Planning & Zoning Board Meeting

ZONING MEMORANDUM

Meritage Homes- Elevation/ Architectural Plans Hillside Groves (The Reserve PUD) Applicant: Meritage Homes

Meritage Homes 4R60 (Formerly Marigold)

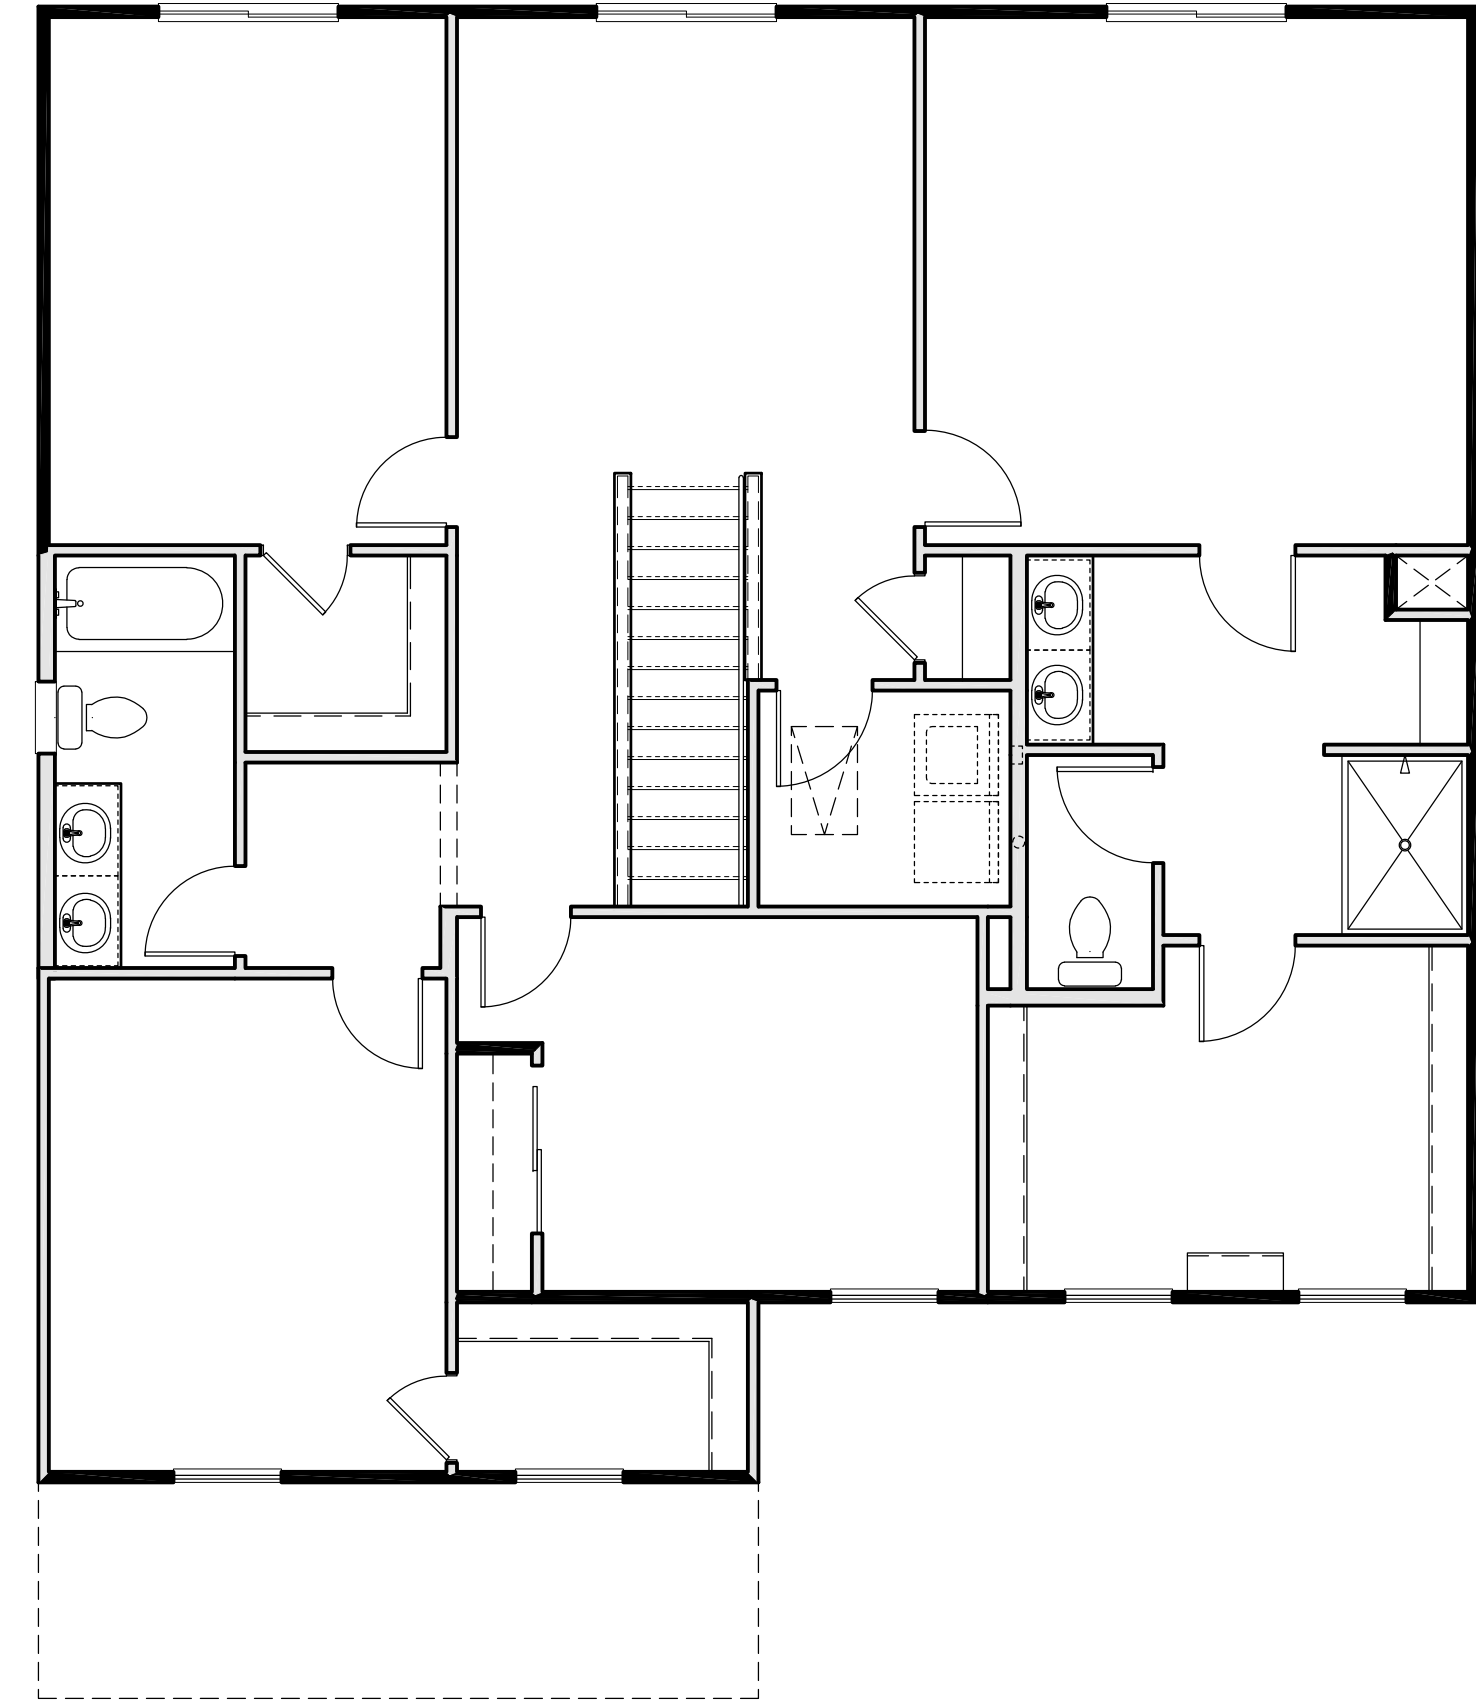
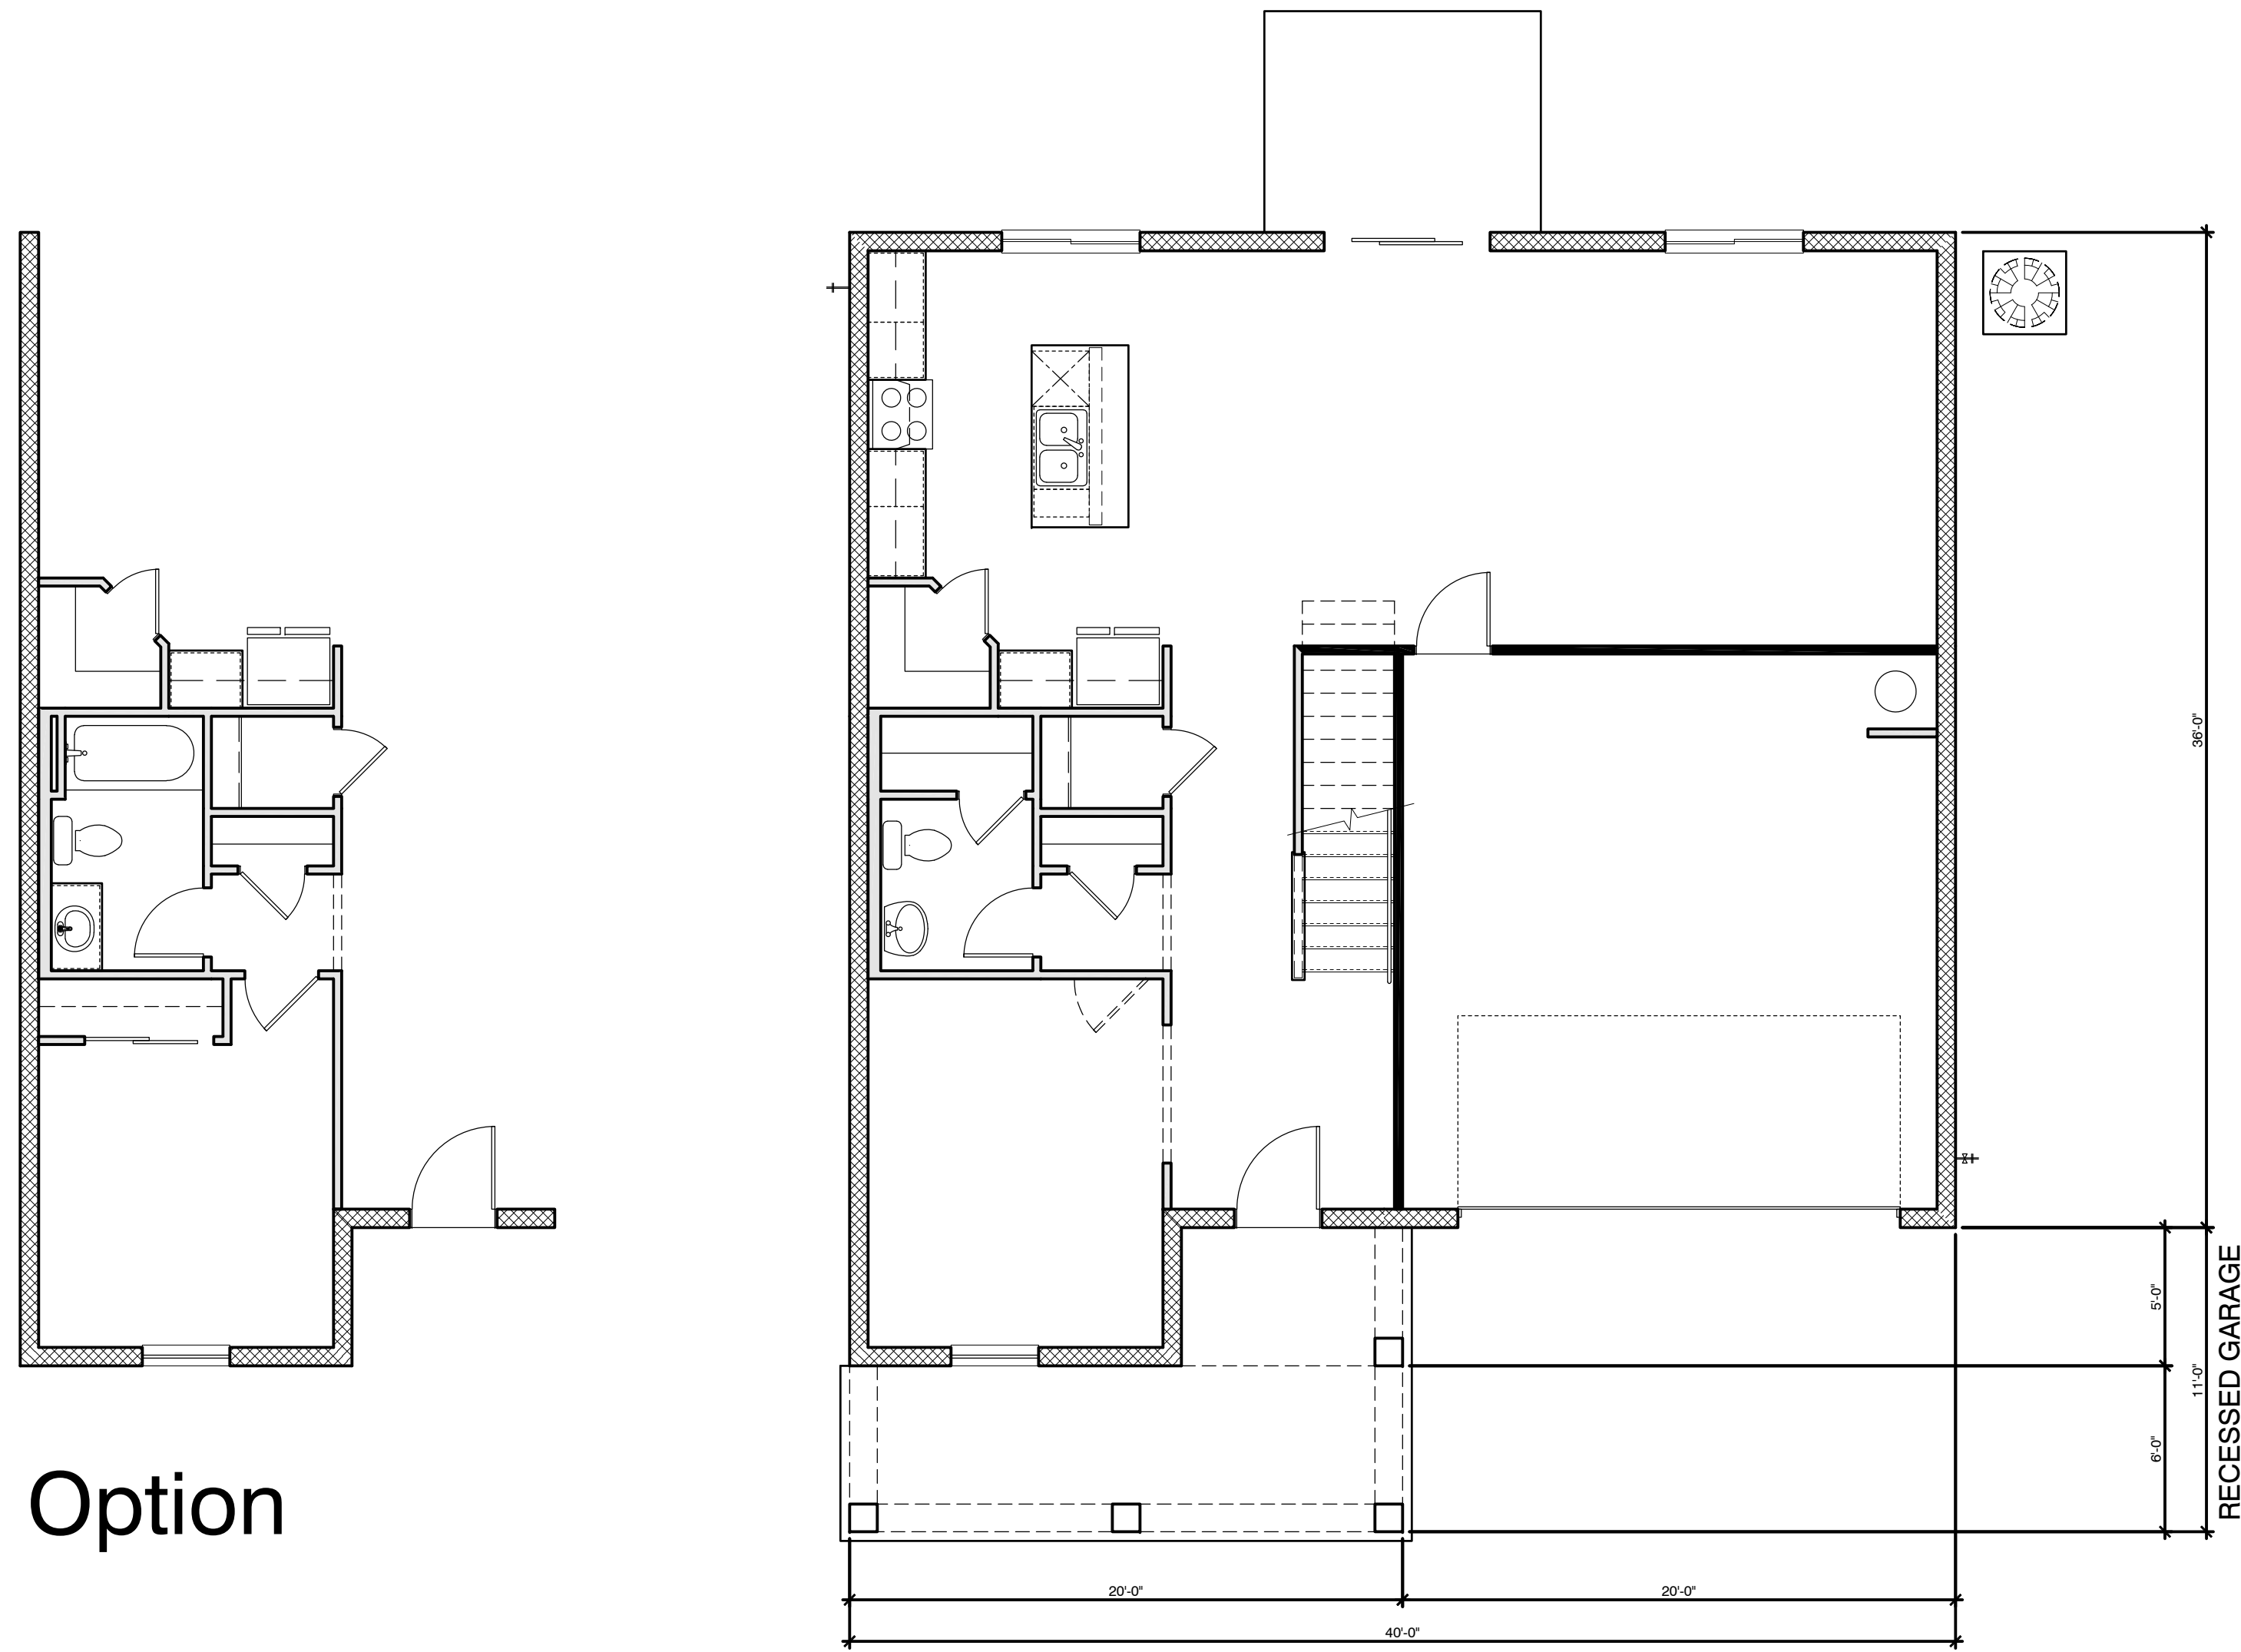
The proposed models appear to provide porches and recessed garages consistent with LDC Sec. 4.06.02 (A) (2) and (3). Additional detail on the porches would be helpful though to determine if they are at or above grade or have articulation designating them as usable front porches. As an example, none of the porches show railings as part of the design.

The proposed elevations show what appears to be stonework and varying materials on the models, however no product types, colors or materials are identified on the plans. The elevation plans need to be revised to demonstrate and specify materials to ensure that they are consistent with the following LDC Sections which state:

The proposed elevations do not identify the roof materials to be used nor detail on eave design. The plans need to be revised to demonstrate and specify roof materials and eaves detail to ensure that they are consistent with the following LDC Sections:

The application provides some of these details but not all that are required for each of the facades. Consistent with LDC Sec. 4.06.03, the plans need to be revised to show and label the front, side, and rear facade elevations for each model and identify the specific architectural details on each façade, demonstrating how they are consistent with the type and quantity required in LDC Sec. 4.06.03 (C).

Recommendation: The model elevations should be revised consistent with the requirements identified in the review comments below and be brought back to the Planning and Zoning Board for consideration.
